# GENESEE PROPANE BULK PLANT

MARK	REVISION	DATE
	RESUBMITTAL	05/15/2023

SITE PLAN

# A1.1P

1 SITE PLAN  
1"=20'

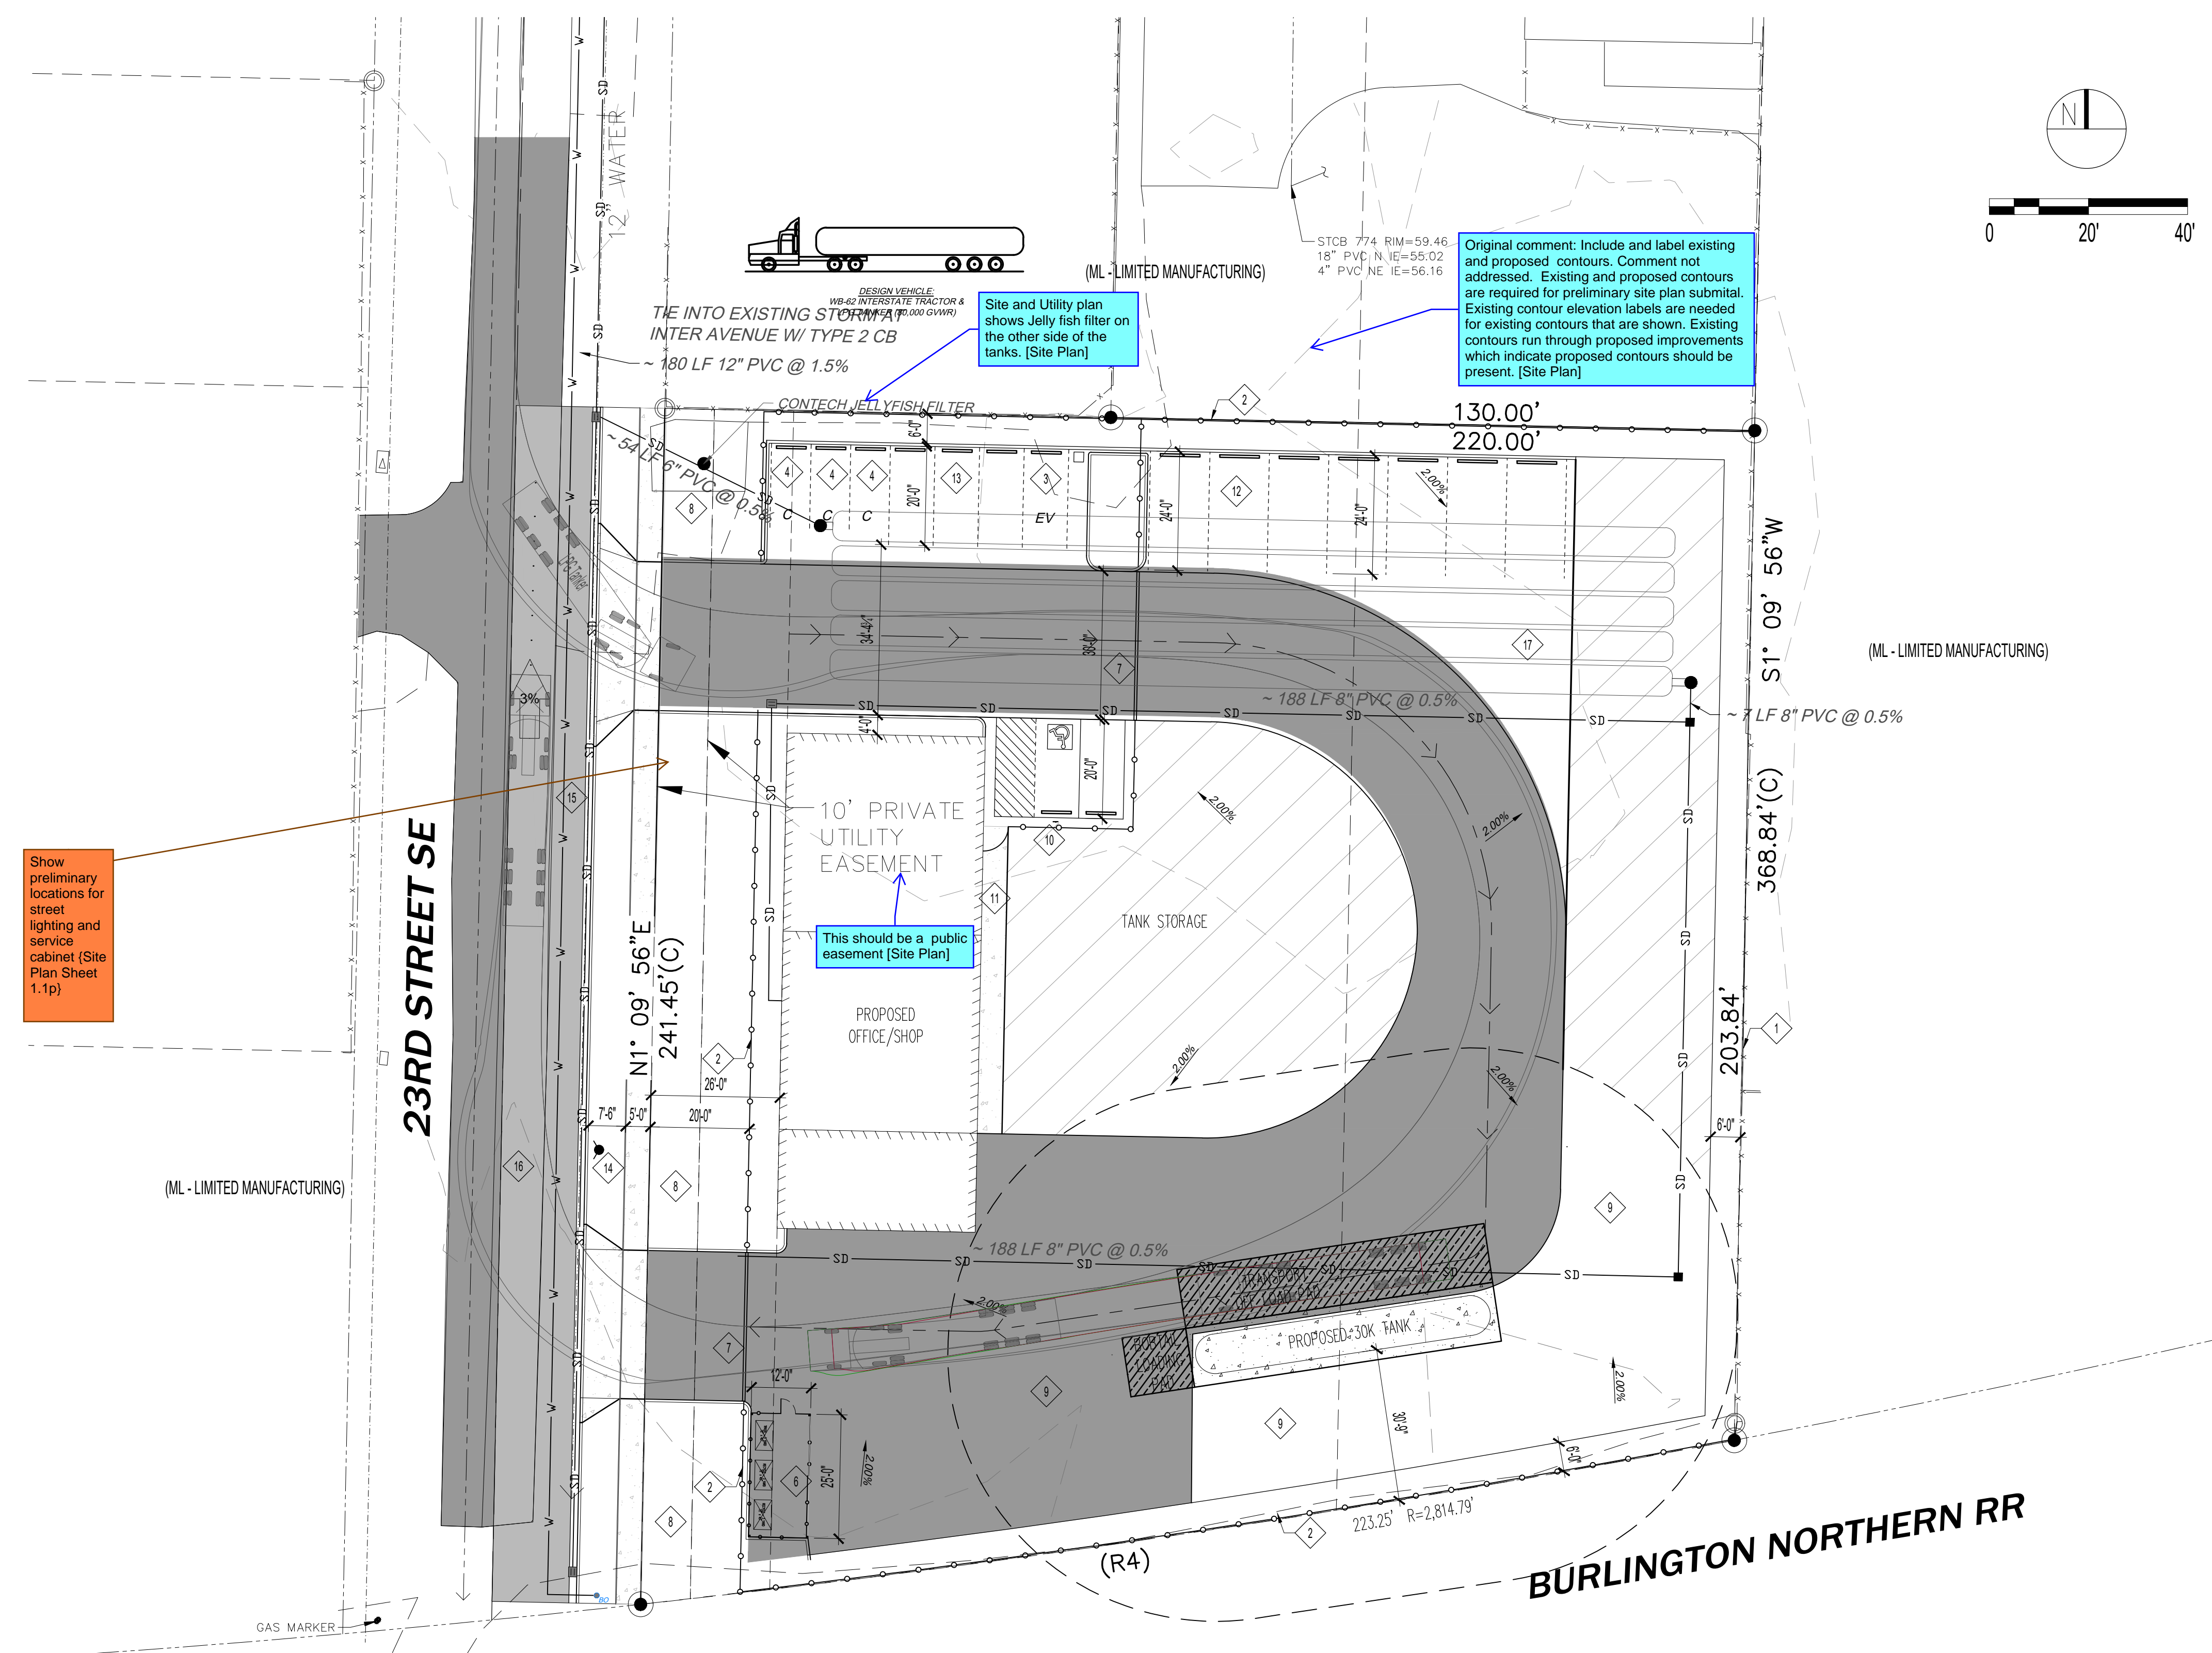
Show preliminary locations for street lighting and service cabinet (Site Plan Sheet 1.1p)

Original comment: Include and label existing and proposed contours. Comment not addressed. Existing and proposed contours are required for preliminary site plan submittal. Existing contour elevation labels are needed for existing contours that are shown. Existing contours run through proposed improvements which indicate proposed contours should be present. [Site Plan]

Site and Utility plan shows Jelly fish filter on the other side of the tanks. [Site Plan]

This should be a public easement [Site Plan]
